Great Lakes UK Limited
Great Wolf Lodge, Chesterton, Bicester

Non Material Amendment (S.96a) Application
Design Changes

March 2023

2.2 Scheme Changes Update Proposed Amended Scheme - Roof Plan

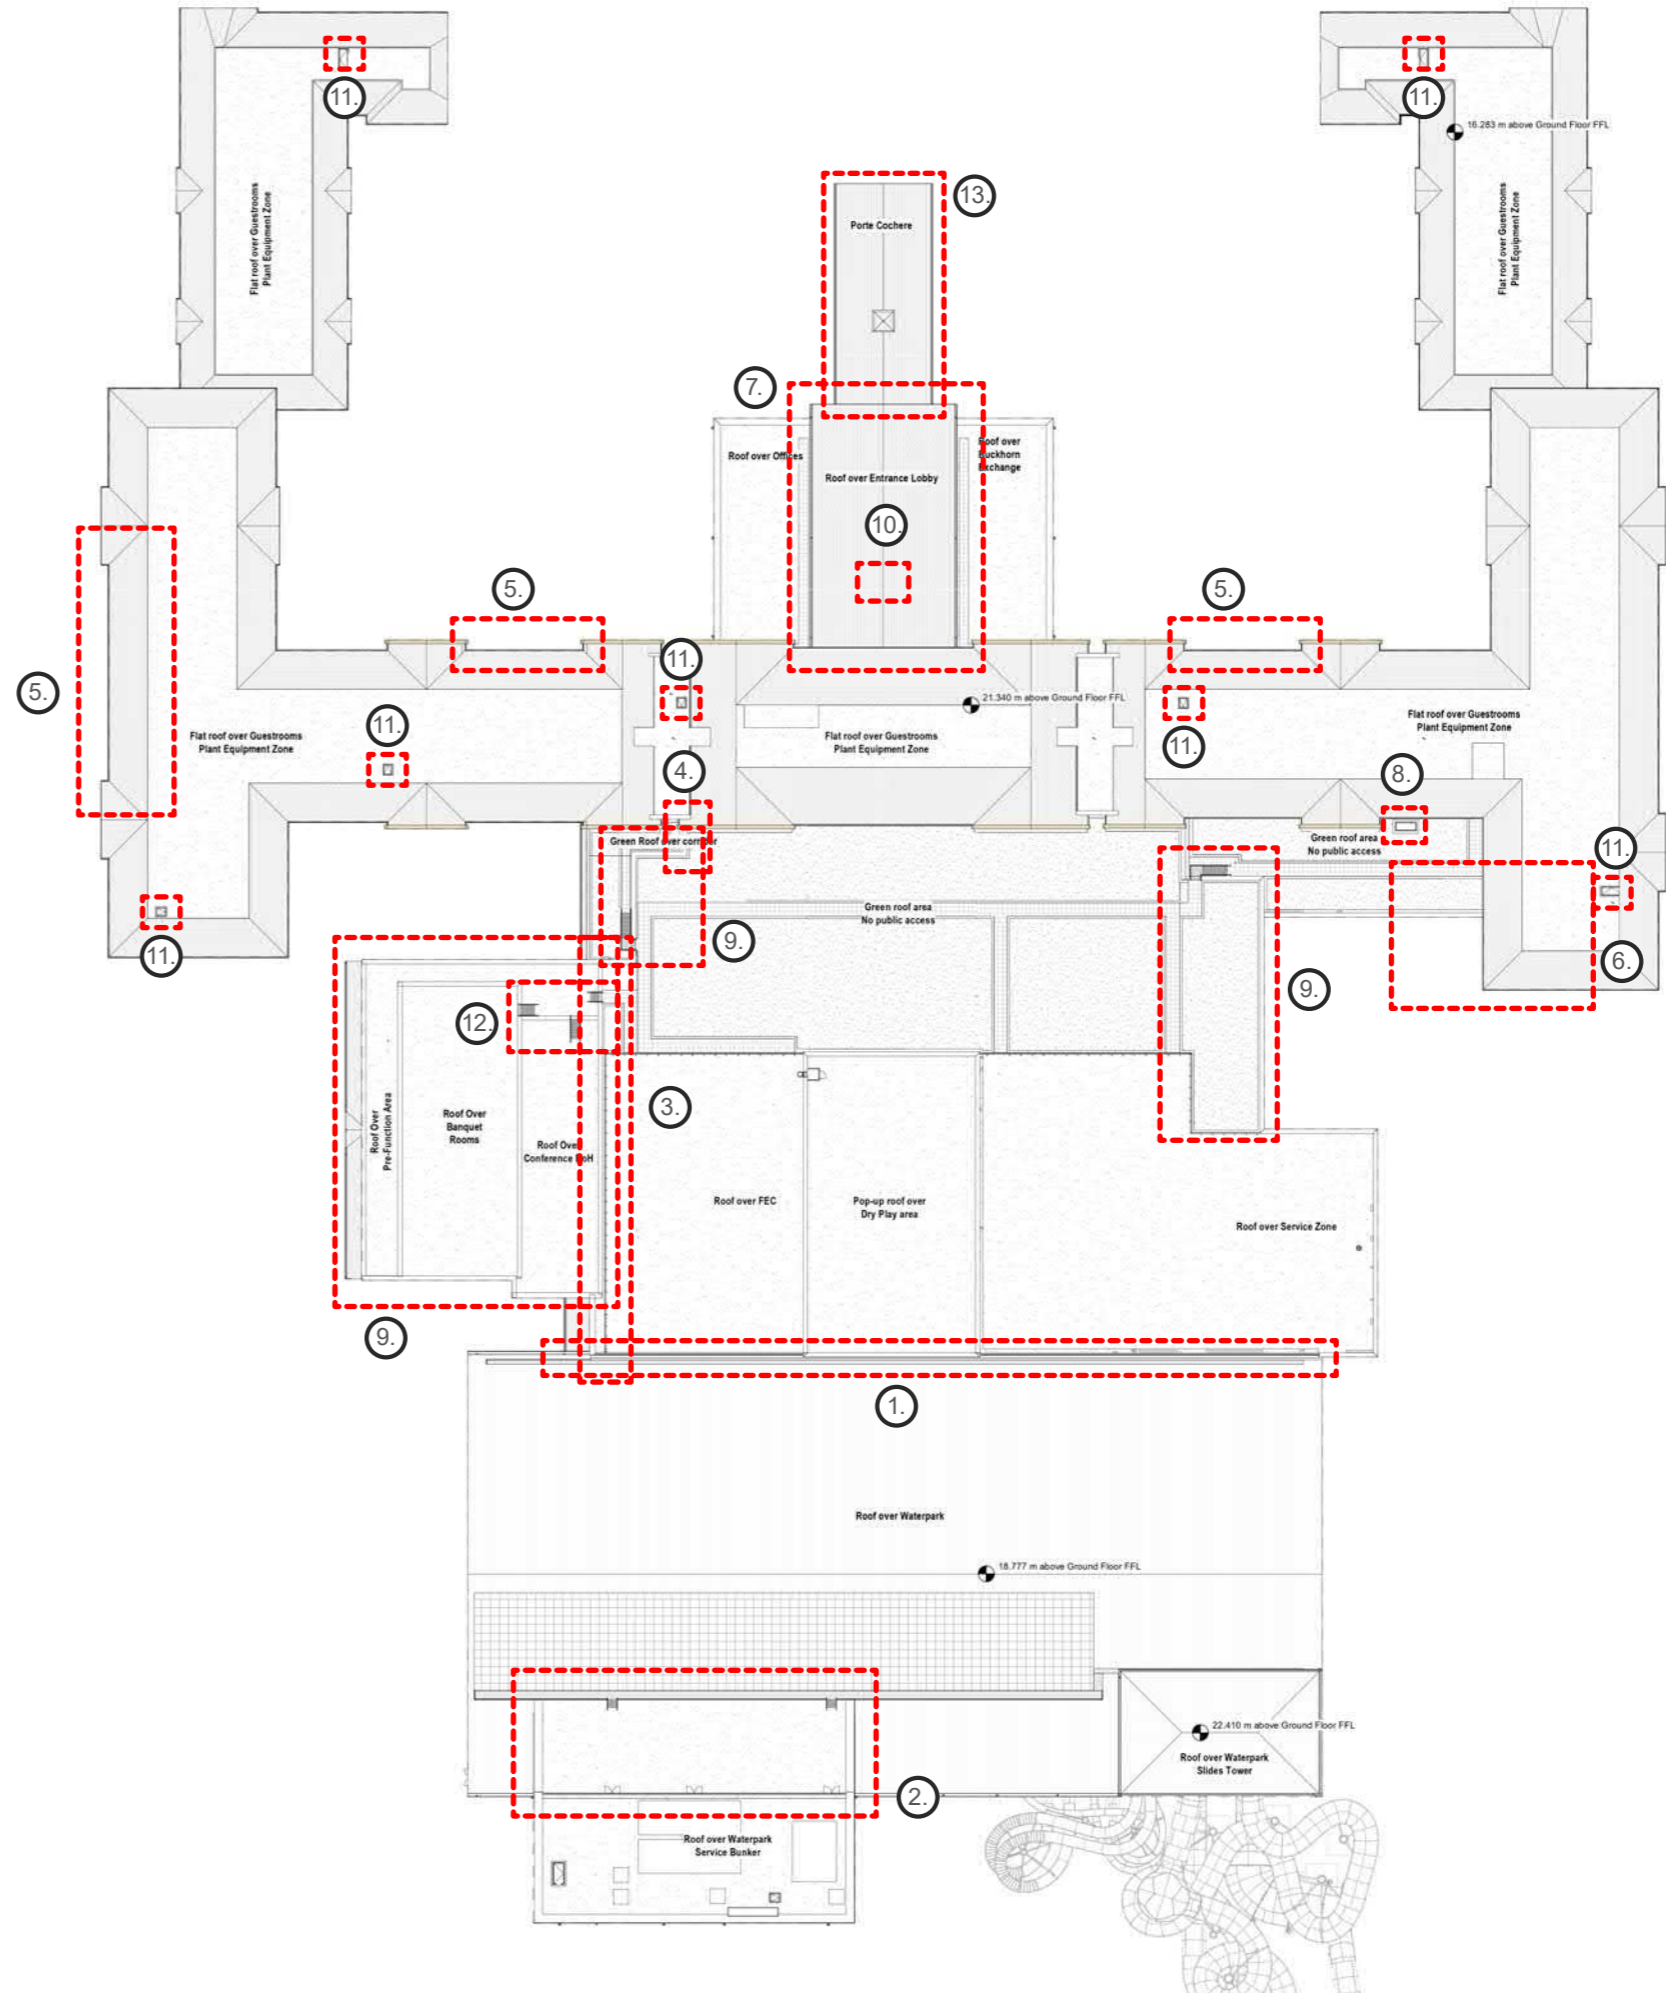
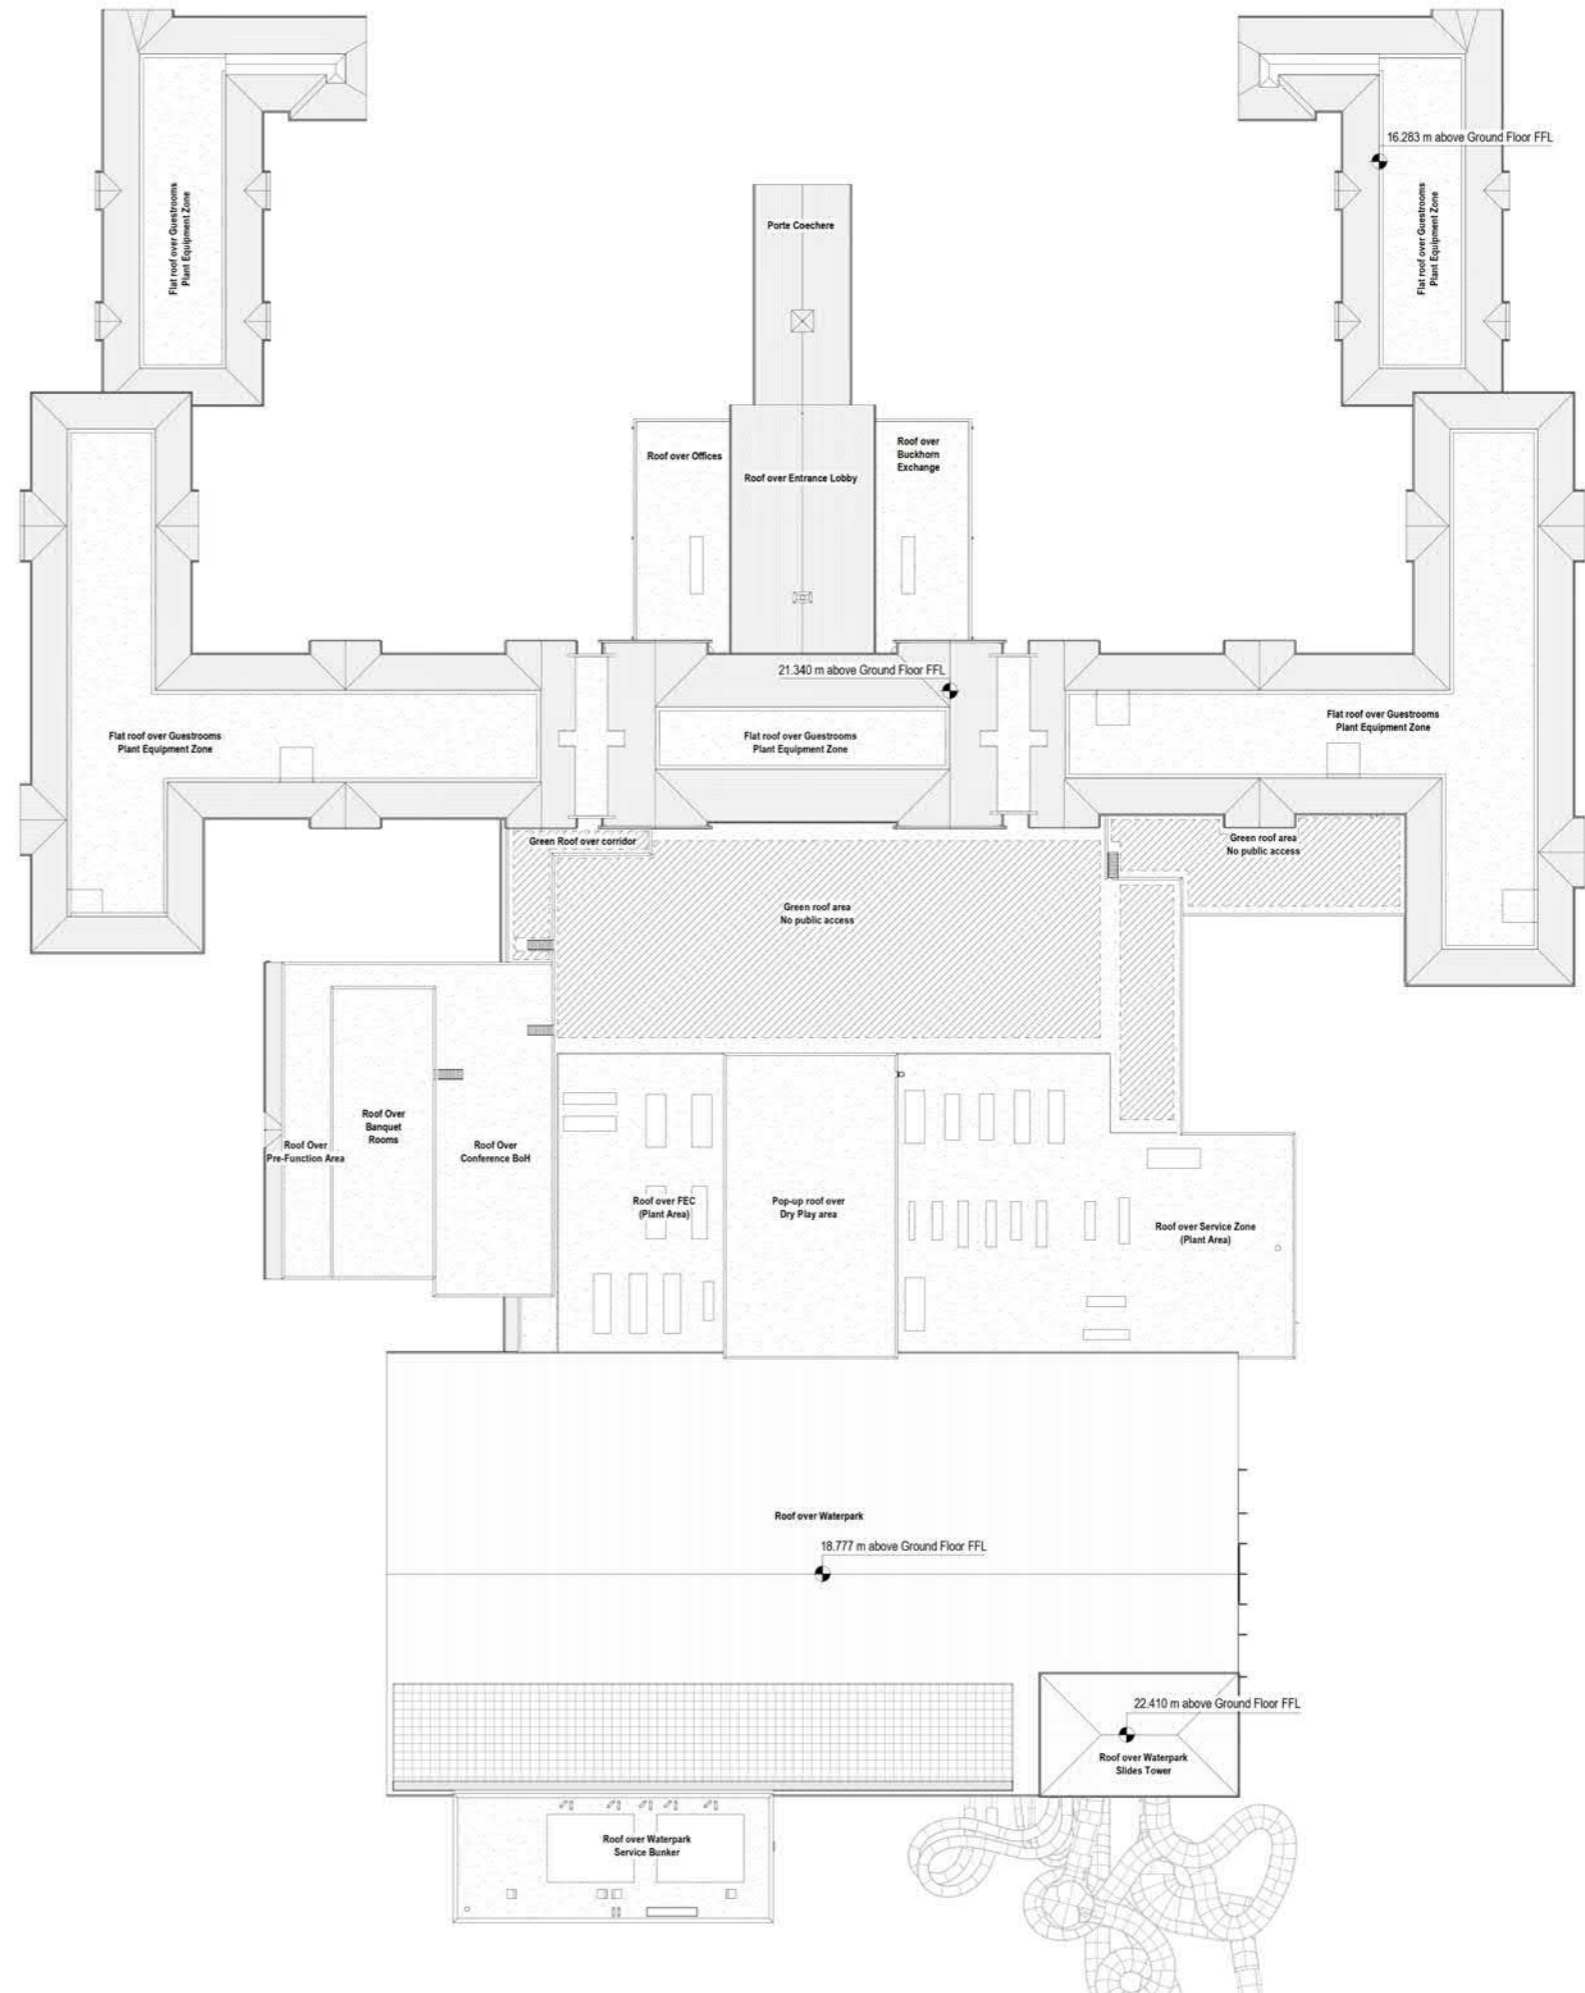
- ① Parapet wall created to roof of FEC roof to provide positive edge to waterpark roof for good roofing design practice and waterproofing.
- ② Bunker roof now extends in to the waterpark roof as a dormer.

- ③ Update to roof of the FEC to conference centre. Parapet wall pushed towards the conference centre side.
- ④ Parapet line moved left to move steels out of the party room.

- ⑤ Rain water pipes moved on NE and NW elevations.
- ⑥ Flue on green roof and louvres on wall facing service yard omitted.
- ⑦ Roof above hotel lobby dropped by approx. 990mm as a result of building design efficiency.

- ⑧ Louvred pop up on the roof over the laundry room added for ventilation purposes
- ⑨ Minor changes to balustrade / railing design and stair locations.

- ⑩ Chimneys removed.
- ⑪ Stair overruns removed and replaced with hatches and ladder access to the roof.
- ⑫ Access steps moved.
- ⑬ Small increase in height to Porte Cochere roof.
